TOWN OF CORTLANDT PLANNING BOARD

WORK SESSION.....JULY 1, 2025 6:00 PM

MEETING AGENDA.....PLANNING BOARD
TOWN OF CORTLANDT
6:30 TUESDAY EVENING*
JULY 1, 2025

PROPOSED LEAF-OFF

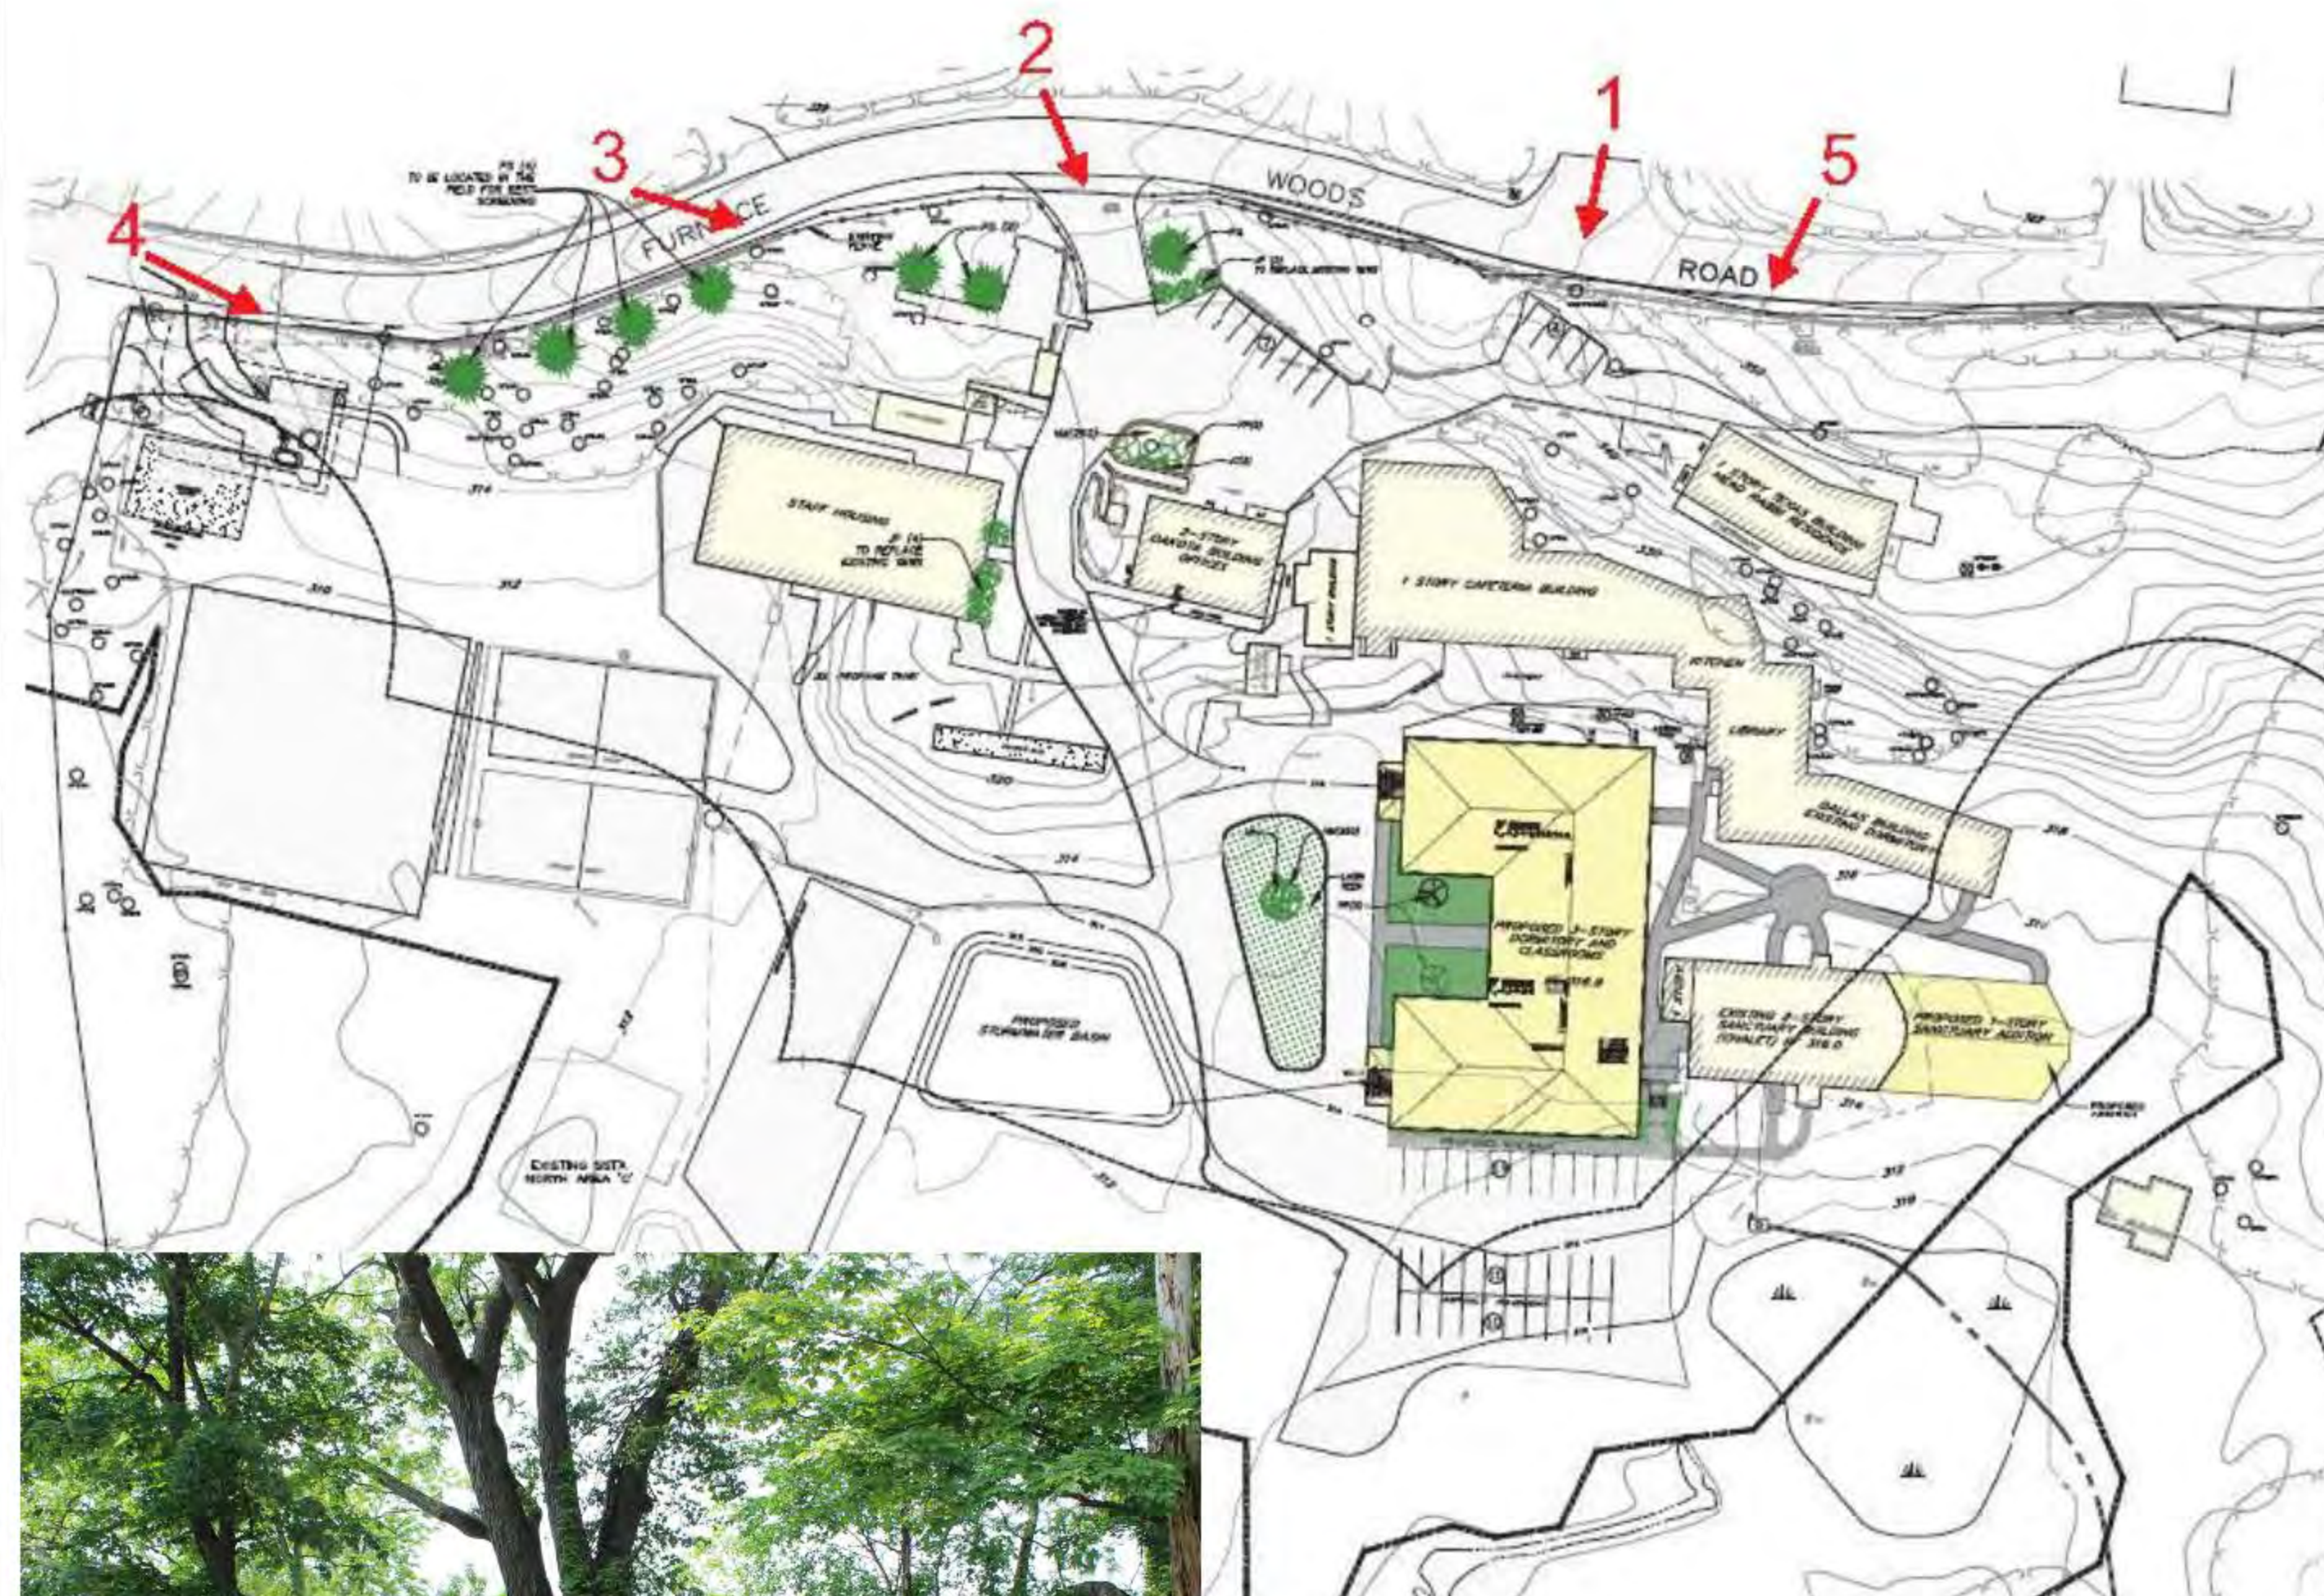
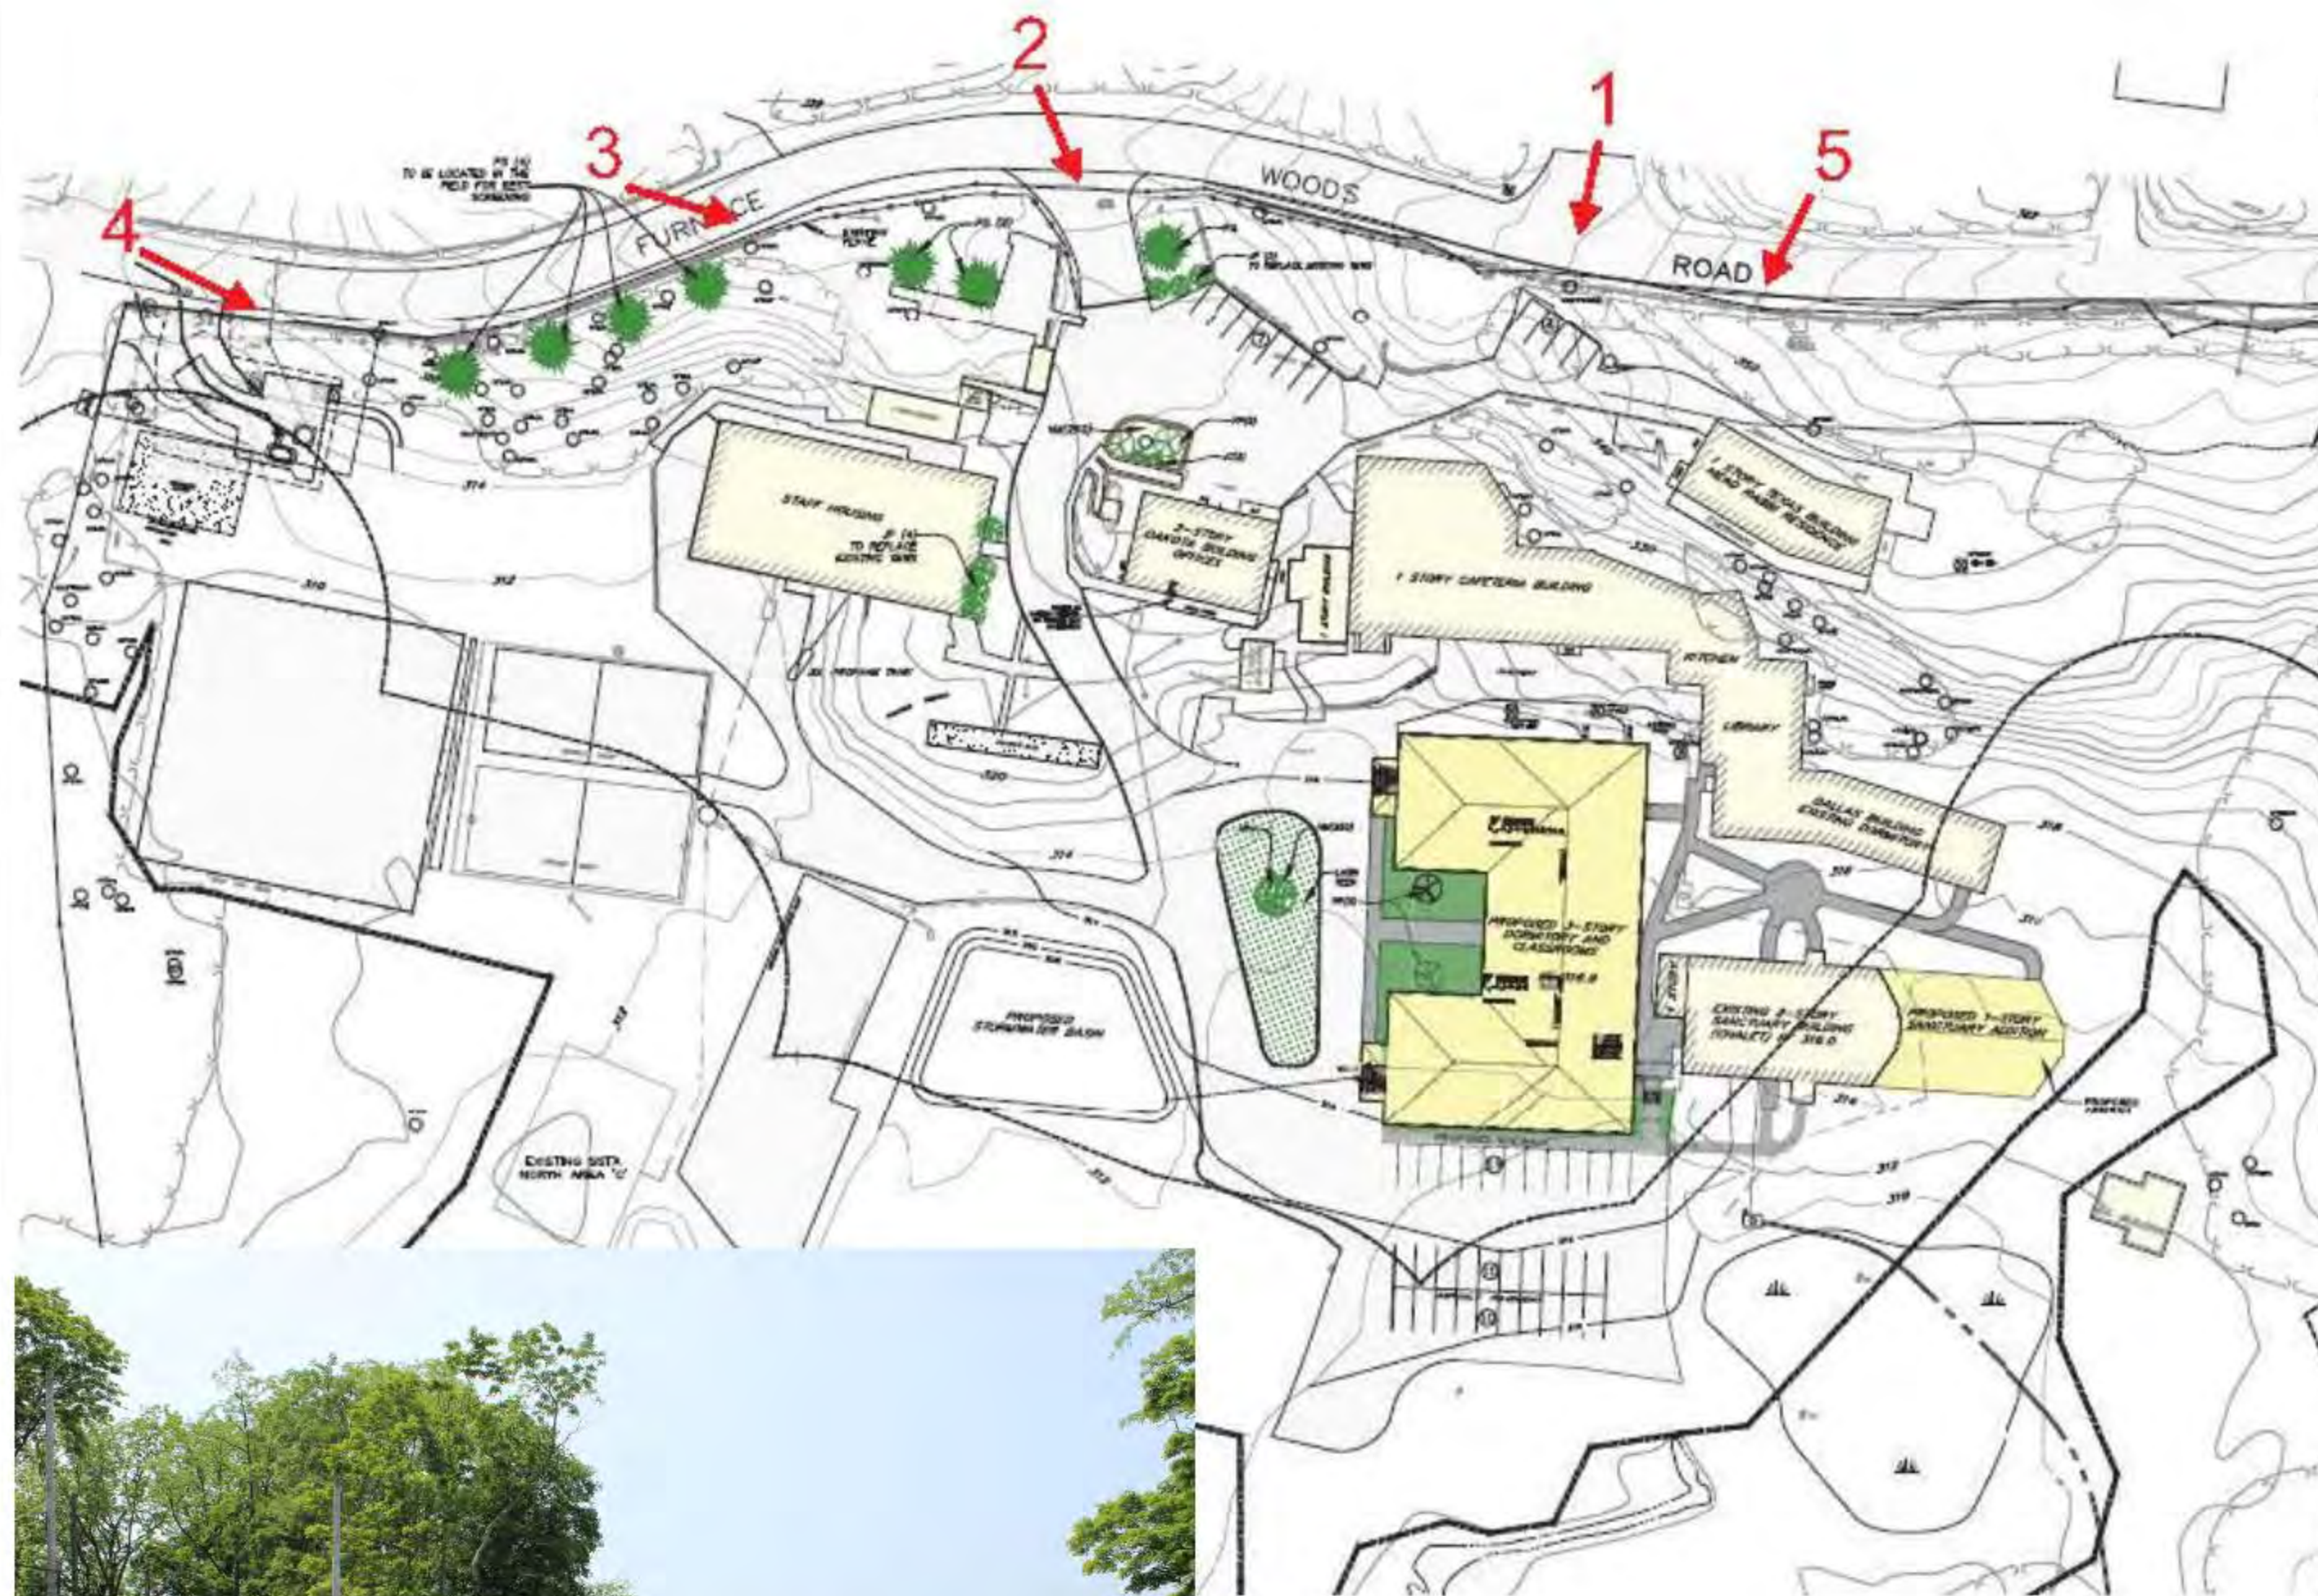
2. **Visual Impacts:** At their May meeting, the Planning Board requested the applicant provide views of the new dormitory building from the nearby public road. Views should be shown from multiple points along Furnace Woods Road, in both leaf-on and leaf-off conditions. In addition to the site line shown on Sheet 7, we suggest capturing views southbound from the vicinity of 165 Furnace Woods Road, northbound from the vicinity of 130-136 Furnace Woods Road, and from the site entrance.
